**COUNCIL ACTION FORM**

**SUBJECT: SOMERSET SUBDIVISION 25<sup>TH</sup> ADDITION – PRELIMINARY PLAT / MAJOR SITE DEVELOPMENT PLAN REVISION**

**COMMISSION ACTION FORM**

**REQUEST:** Preliminary Plat/Major Site Development Plan revision for Somerset Subdivision 25<sup>th</sup> Addition

PROJECT NO.  
5000-12R  
SHEET  
Z.01

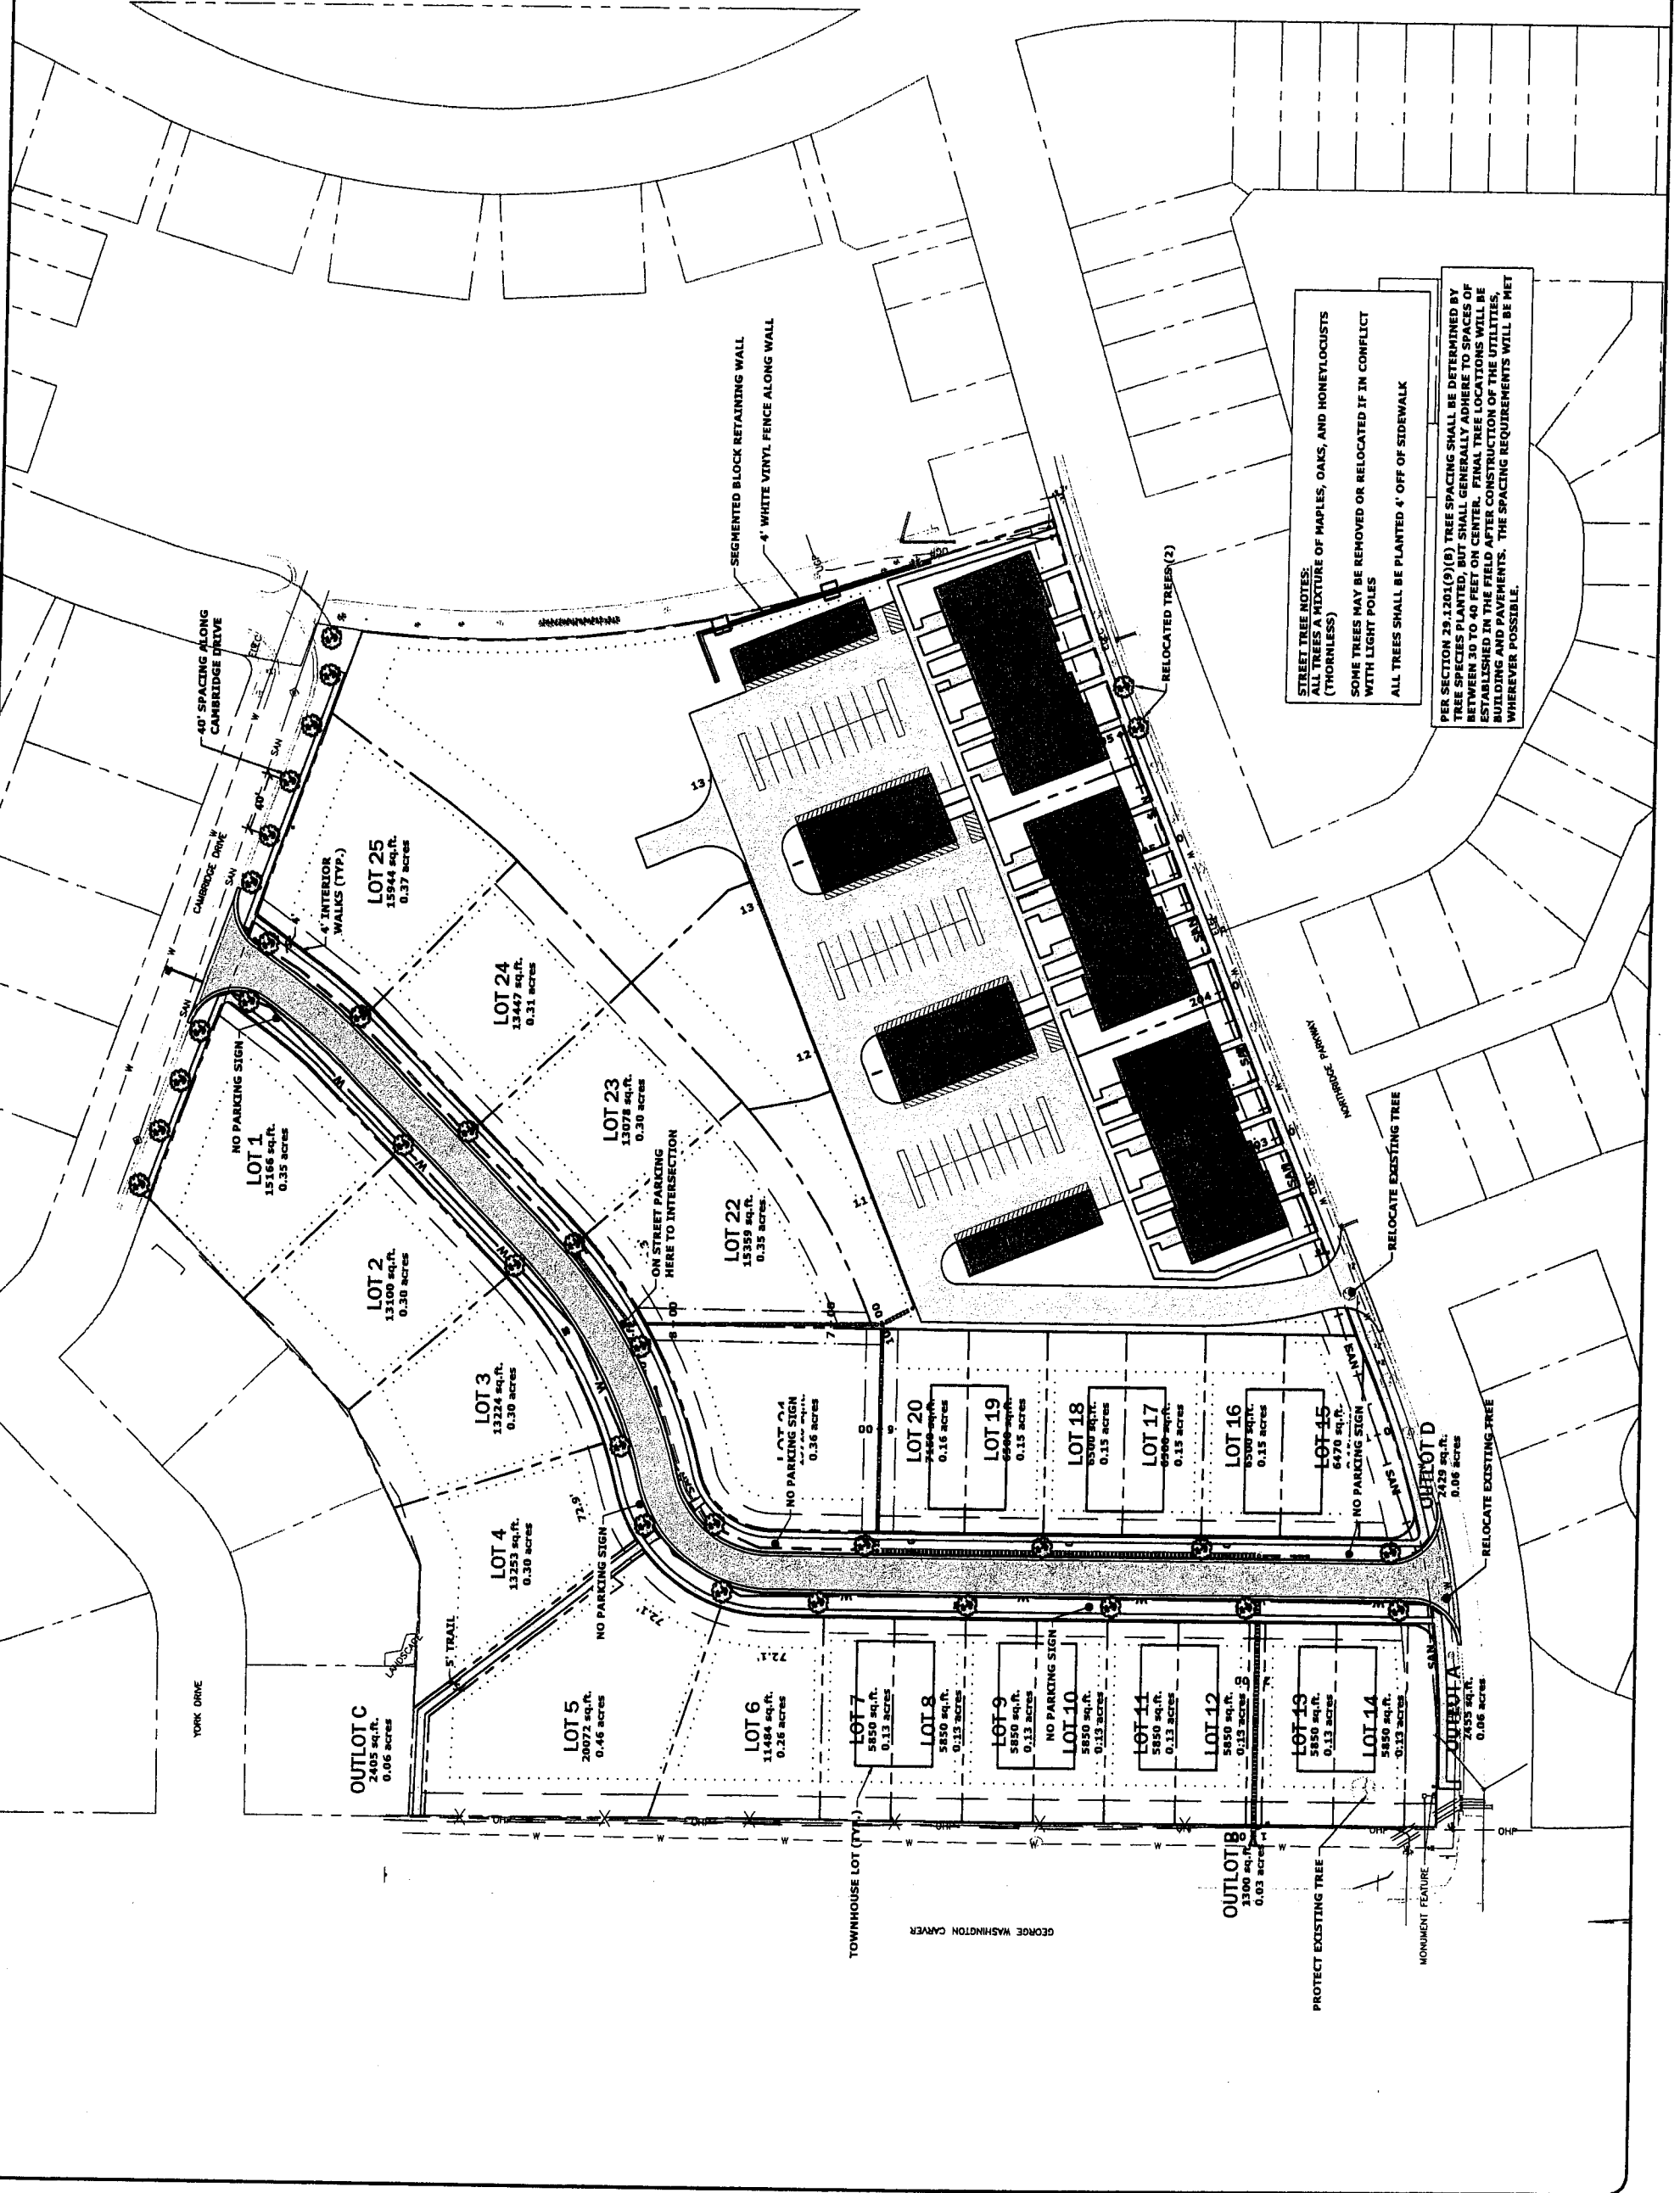
Where the proposed school previously would have separated traffic routes between the north and south parts of the west half of Somerset, the Plan now provides a public street and sidewalks to connect Cambridge Street on the north with Northridge Parkway on the south. In the middle of this block face, a pedestrian walk extends northwest connecting to the existing walk northward on George W. Carver Avenue. This system provides a pedestrian connection between the south and north parts of Somerset. (See attached Street Tree Plan, Sheet Z.01 of proposed plans)

**Village Residential Park and Open Space Requirements.** *Ames Municipal Code* Section 29.1201(8) states: “The plan for the Village Residential Project shall include an evenly distributed system of park and open space areas, that totals a minimum of 10% of the area of the project.” The percentage requirement is addressed above. Somerset already includes an evenly distributed system of park areas, with one park across Northridge Parkway and a green space trail north of the subject site. The Plan provides one more green space, which will be landscaped and preserved by its designation as Private Green on the Floating Zone Uses drawing. These requirements also include standards for street trees, which are met by the Street Tree Plan, Sheet Z.01 of the proposed plans, attached.
